An
Bord
Pleanála

Inspector's Report ABP318967-24

Development	Vehicular access and driveway.
Location	No. 27 Hardiman Road, Drumcondra, Dublin 9.
Planning Authority	Dublin City Council.
Planning Authority Reg. Ref.	WEB1984/23.
Applicant(s)	Aogan O'Fearthail & Frances Ui Fearthail.
Type of Application	Permission.
Planning Authority Decision	Refusal.
Type of Appeal	First Party
Appellant(s)	Aogan O'Fearthail & Frances Ui Fearthail.
Observer(s)	None.
Date of Site Inspection	20/03/24.
Inspector	Anthony Abbott King

Figure 1: Street Trees and Vehicular Entrances

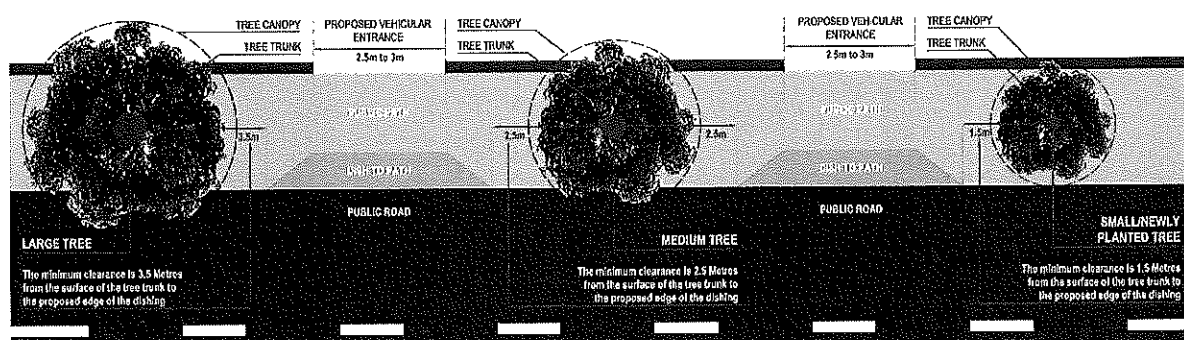
- 7.9. I consider that the subject street tree is a medium size tree. Therefore, a clearance distance of 2500mm is required from the surface of the tree trunk to the vehicular access dishing (See above Figure 1: Street Trees and Vehicular Entrances). The proposed separation distance from the tree trunk is given by the applicant as 2536mm. However, this measurement appears to be from the centre of the tree trunk rather than the surface of the trunk. The relevant separation distance measured to the surface of the tree trunk is 2400mm, which is a marginally deficient clearance distance.

- 7.12. The vehicular access and associated dishing would leave a deficient residual separation distance to the tree trunk surface of approximately 1300mm. The appellant cannot extend the clearance distance by repositioning the access to the east, as the proposed vehicular entrance is tight to the eastern property boundary. I consider given the deficient clearance distance that would result from the dishing of the area to the west of the proposed vehicular entrance, within the recommended clearance buffer zone provided by Figure 1 (Street Trees and Vehicular Entrances), that there is potential to damage the root system of the street tree.

7.16. A minimum clearance of 2500mm is required by Appendix 5, Section 4.3.2 (Impact on Street Trees) of the Dublin City Development Plan 2022-2028. I conclude that there is significant risk that the root system of the subject tree would be damaged by the proposed development works given the deficient clearance distance from the dishing to the surface of the tree trunk.
